Carolina Power & Light Company

SERIAL: NLS-87-262
10CFR50.62

BRUNSWICK STEAM ELECTRIC PLANT, UNIT NOS. 1 AND 2
DOCKET NOS. 50-325 & 50-324/LICENSE NOS. DPR-71 & DPR-62
ATWS-ARI DRAWINGS

ALTERNATE ROD INJECTION SYSTEM

CAROLINA POWER & LIGHT CO
 BRUNSWICK STEAM ELECTRIC PLANT
 UNIT NO. 2-C12
 CONTROL ROD DRIVE SYSTEM
 SOLENOID VALVE LOGIC
 SH.7 CONTROL WIRING DIAGRAM
 DWG NO. LL-09046 SECT. AH.7

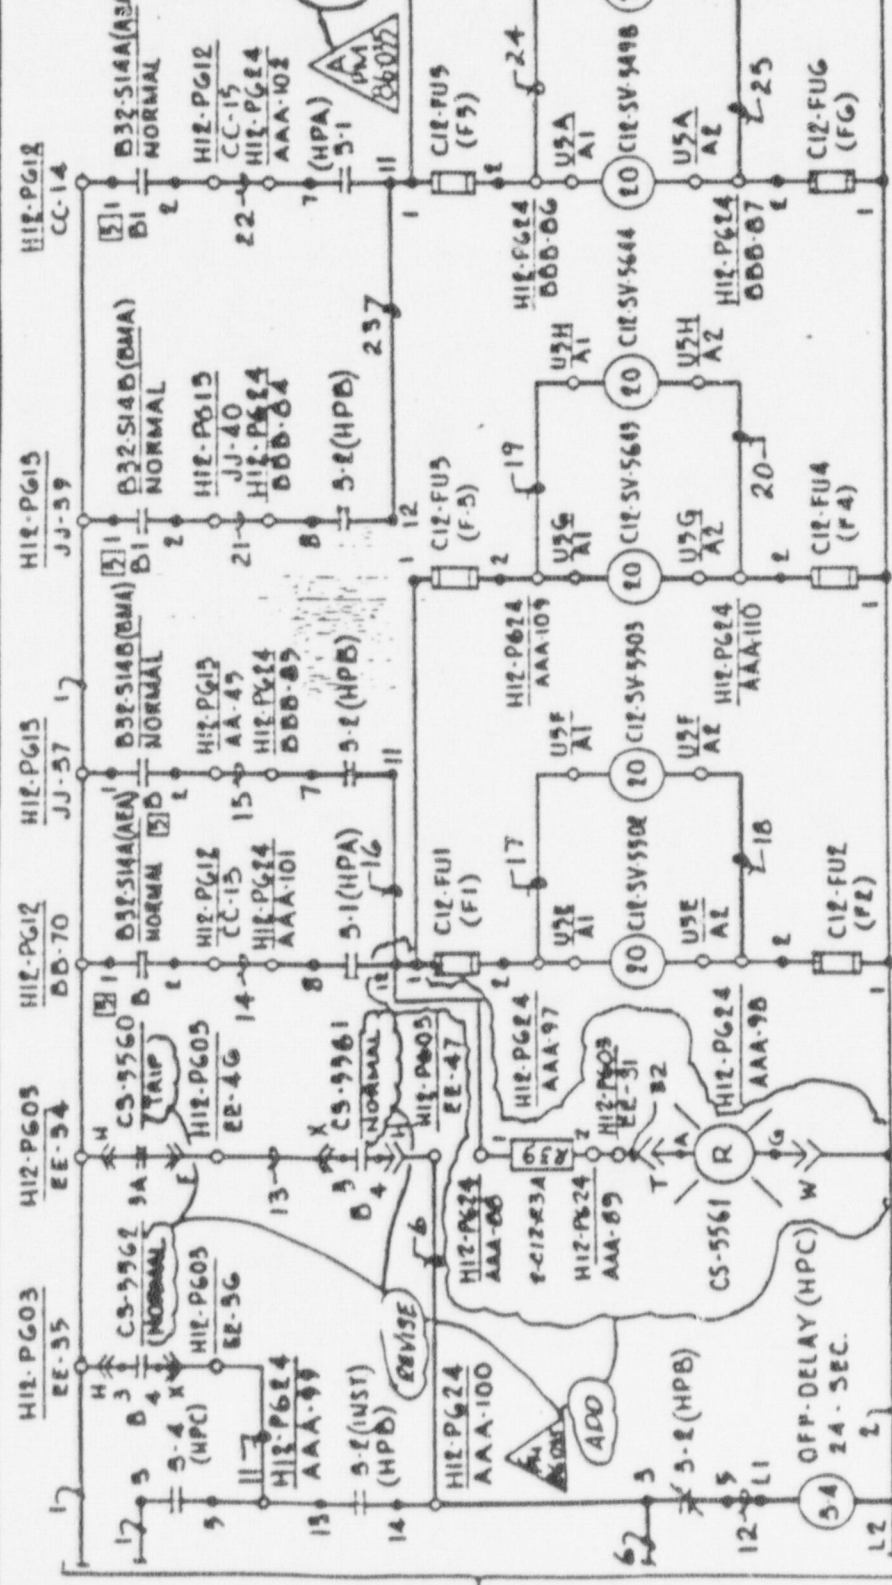
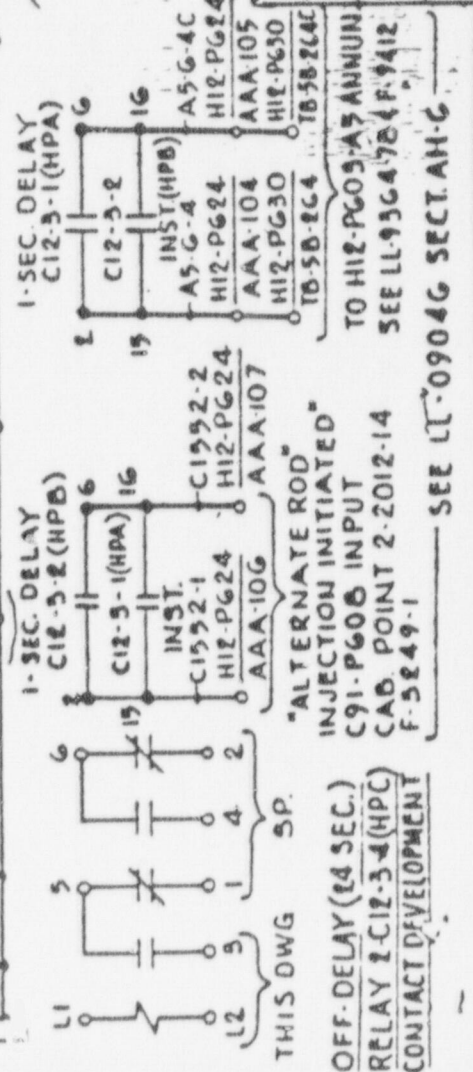
Carolina Power & Light Company has changed the design of the ARI system to address the NRC concerns discussed in the September 18, 1987 SER. The ARI system has been redesigned to allow testing at power without preventing the system from providing its intended protection while testing is in progress. The enclosed drawings, which replace Figures 10, 11, and 12 of CP&L's June 18, 1987 submittal, show these changes. More contacts were added to the test isolation switches to allow isolation of a single circuit, allowing the other to remain available for ARI initiation.
